To: T10 Technical Committee
From: Rob Elliott, HP (elliott@hp.com)
Date: 23 October 2007
Subject: 07-449r0 SAS-2 Mini SAS 8i connectors and cable assemblies

Suggested changes to SAS-2

Figure 74 — Mini SAS 8i cable plug connector [\[new figure needed showing 8i, not 4i\]](#)

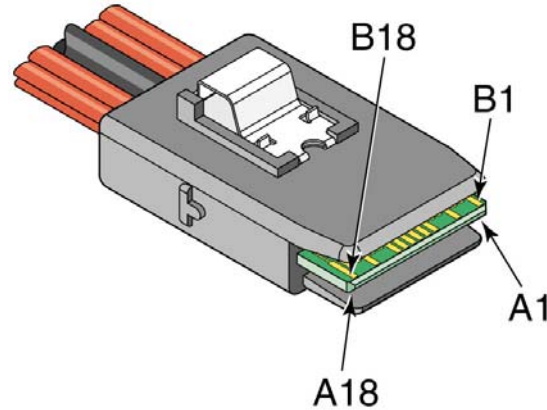
The Mini SAS 8i cable plug connector is the free (plug) 68-circuit Unshielded Compact Multilane connector defined in SFF-8087 and SFF-8086.

Figure 75 — Mini SAS 8i receptacle connector [\[new figure needed showing 8i, not 4i\]](#)

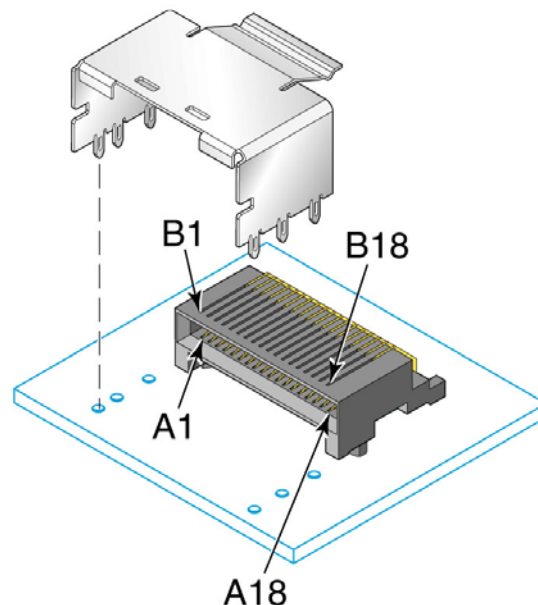
The Mini SAS 8i receptacle connector is the fixed (receptacle) 36-circuit Unshielded Compact Multilane connector defined in SFF-8087 and SFF-8086.

Figure 78 — SAS internal symmetric cable assembly - Mini SAS 8i

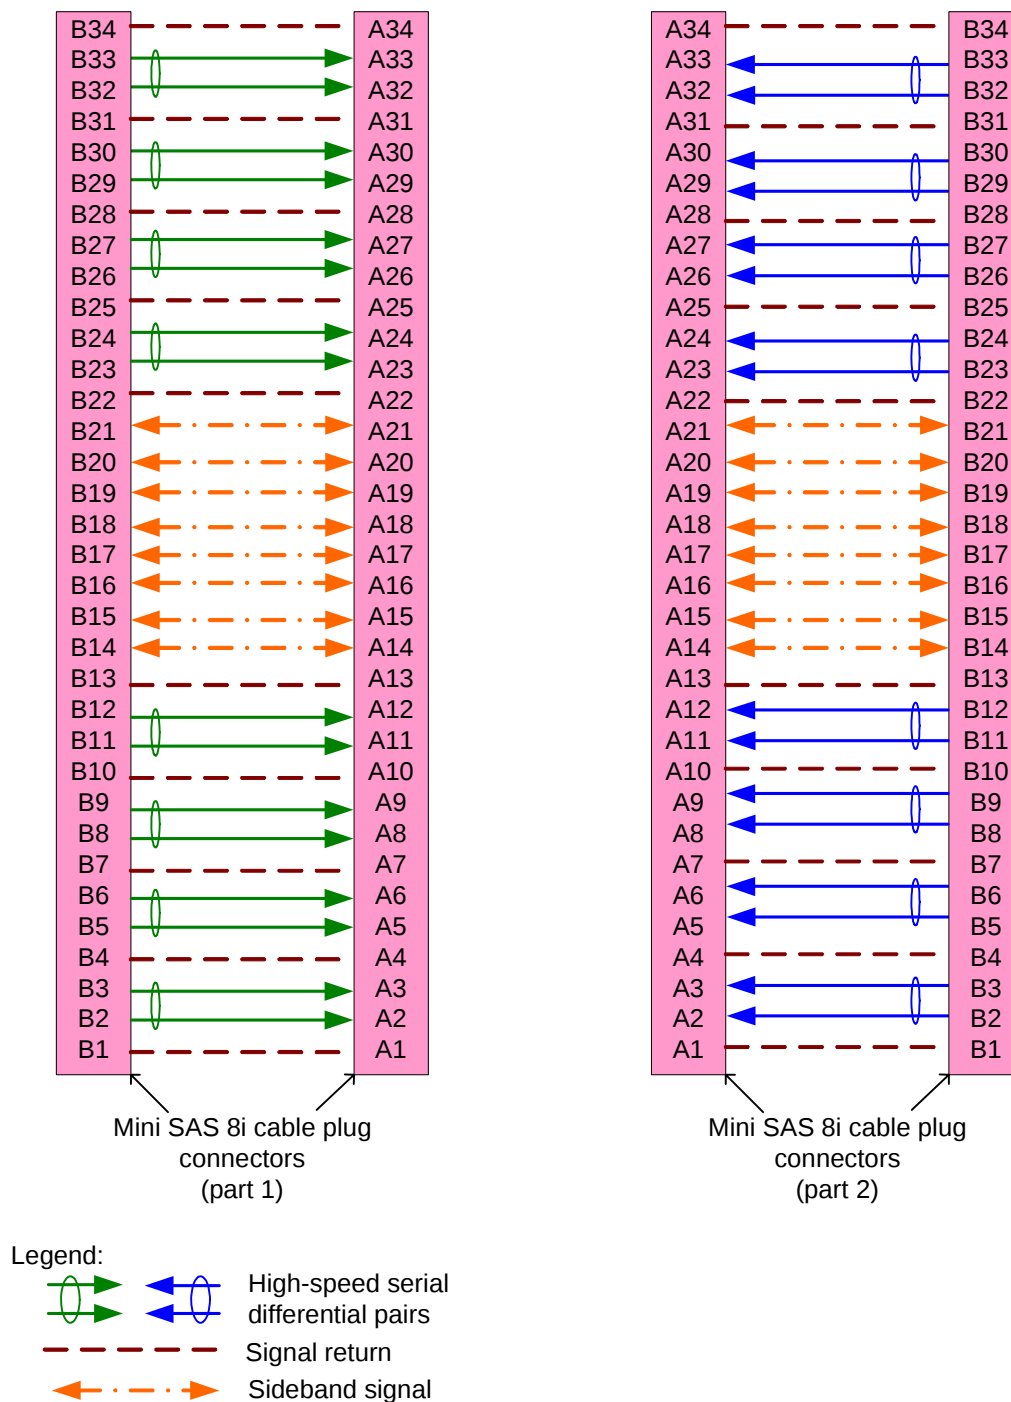
Figure 77 shows the SAS internal cable assembly with Mini SAS 8i cable plug connectors at each end.

The cable assembly may support one to eight physical links.

For controller-to-backplane applications, SIDEBAND signals on the controller are attached to the corresponding SIDEBAND signals on the backplane (e.g., SIDEBAND0 of the controller is attached to SIDEBAND0 of the backplane).

For controller-to-controller applications, SIDEBAND signals on one controller are not attached to their corresponding SIDEBAND signals on the other controller (e.g., SIDEBAND0 of one controller is attached to SIDEBAND15 of the other controller).

Figure 84 — SAS internal controller-based fanout cable assembly - Mini SAS 8i to two Mini SAS 4i

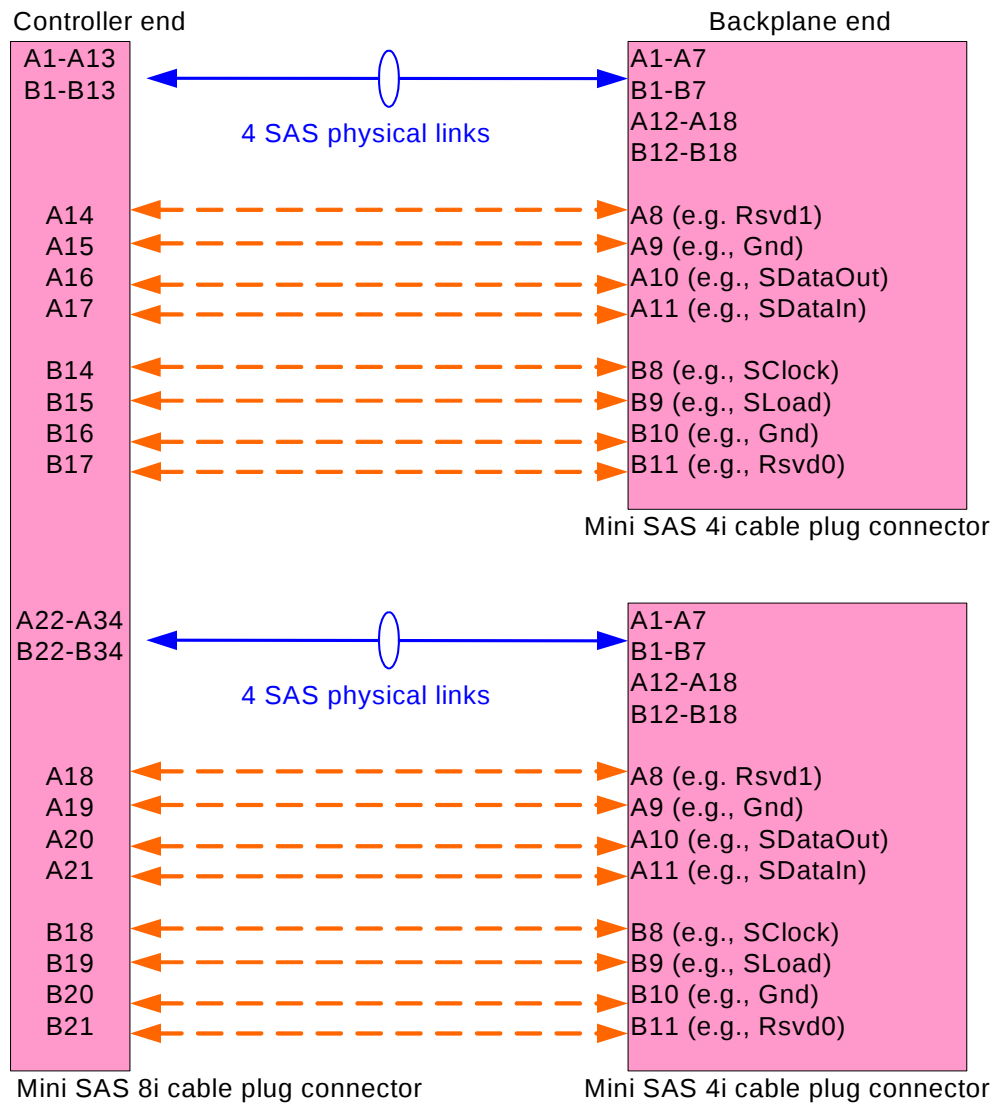
[Figure 84 shows the SAS internal controller-based fanout cable assembly with a Mini SAS 8i cable receptacle connector at the controller end and two Mini SAS 4i cable receptacle connectors at the backplane end.](#)

[The cable assembly shown in figure 84 shall connect each signal return on one end to at least one signal return on the other end. The cable assembly may connect one or more of the signal returns together.](#)
